service bulletin

Bulletin No. 2002-11

Uneven or Increased Handle Effort After Control Installation – Commander 3000 Classic Panel Mount Remote Control

Commander 3000 Classic Panel Mount Remote Control

Misaligned Condition

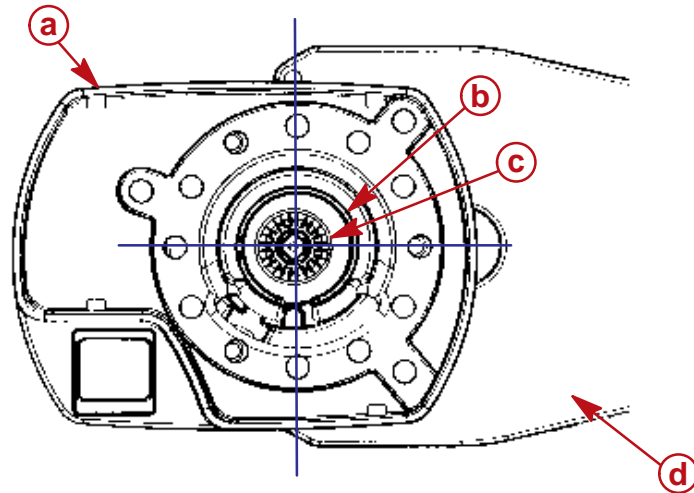
If the amount of effort required to shift the control handle of an affected Commander 3000 panel mount control seems high or feels uneven (easier to shift from neutral to forward or from neutral to reverse and then harder in the opposite direction), the control's bezel may have been misaligned during installation. This condition may be caused by tightening the remote control module to the bezel plate with the remote control handle shaft not properly centered in the bezel plate hub opening. This may occur if the handle is placed into the bushing and bezel opening with the brass handle retaining nut tightened to 17 Nm (150 lb-in.). The handle hub may then rotate in a slightly non-concentric manner, causing the handle to drag or bind in one direction but not the other. If this misalignment condition is extreme, the handle may feel tight in both directions.

Properly Aligned

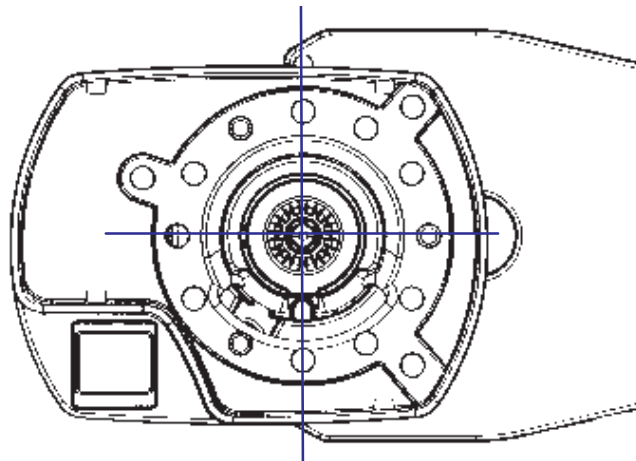
- a** - Bezel
- b** - Handle Hub Opening
- c** - Handle
- d** - Remote Control Module

This procedure may be followed when installing the control for the first time or if this condition is found after the control has been completely installed.

74411

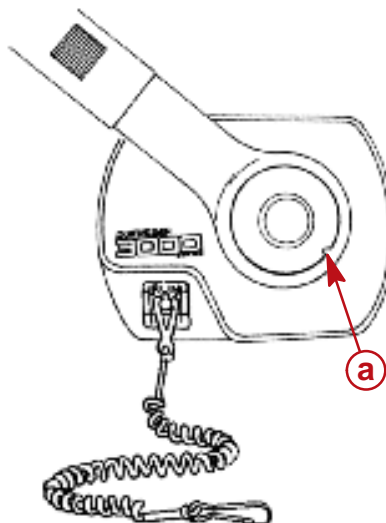
NOTE: Verify that the control handle friction screw located on the hub of the bezel plate is backed off before checking for this condition.

With the shift and throttle cables disconnected from the engine end, rotate the shift/throttle handle to the full throttle positions (both forward and reverse), feeling for handle rotation that is even in both directions. If the handle effort is higher in one direction over the other, remove the throttle only button and the handle nut. Pull off the control handle then remove the bezel cover plate. It is not necessary to remove the trim wiring, just pull the handle assembly out from the bezel and leave the wiring connected.

59551

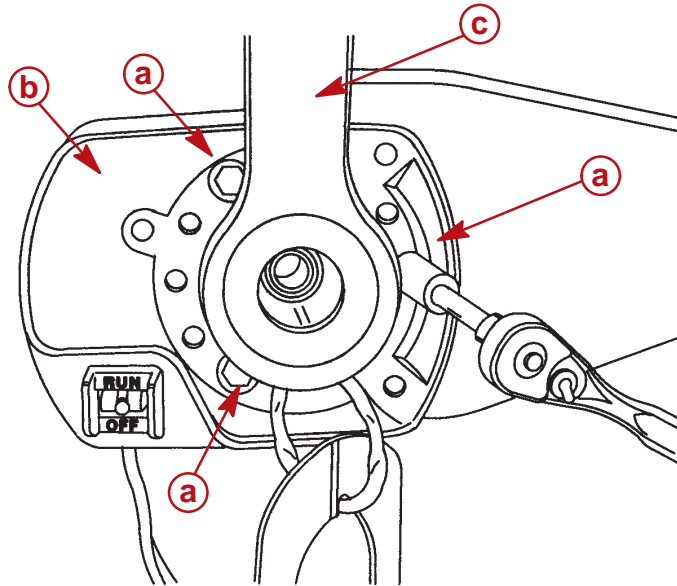
Loosen the (3) 1/4-20 screws securing the module assembly to the bezel plate just enough to allow for module free movement.

Hint: The following instructions are written assuming the original control handle is being used. However, using a spare control handle as an alignment tool makes this procedure easier. You may leave the original handle assembly hang while performing the centering procedure.

Pull the trim switch harness out far enough to allow slack and let the bezel cover plate hang.

59550

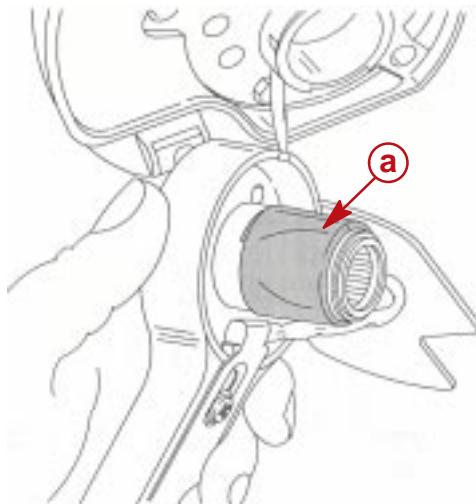
Place the handle hub bushing back into position in the bezel plate opening. Using the handle hub as a centering tool, and with the bezel plate cover out of the way, push the handle hub in firmly towards the module letting the module align itself with the bezel plate. Using a ¼ in. drive 7/16 in. deep well socket and a short extension, begin tightening one or two of the 1/4-20 screws just enough to loosely draw the module up to the bezel plate while rotating the handle back and fourth several times, allowing the module to center itself into position.

Remove the handle assembly and finish tightening the (3) 1/4-20 screws securely. Install the bezel cover plate and handle assembly back into position. Place a small drop of Loctite 271 (only needed if the original locking material seal was broken) onto the brass handle nut threads and tighten to 17 Nm (150 lb-in.). This procedure should help improve the component alignment and reduce or even out the normal handle friction rate. The handle should now rotate in both directions with the same amount of effort. Reconnect the throttle and shift cables at the engine end.

Wrapping a temporary piece of duct tape around the handle hub two times will help center the module to the bezel opening even quicker and may not require rotation of the handle. If used, don't forget to remove the tape before securing the handle to the module for the final assembly.
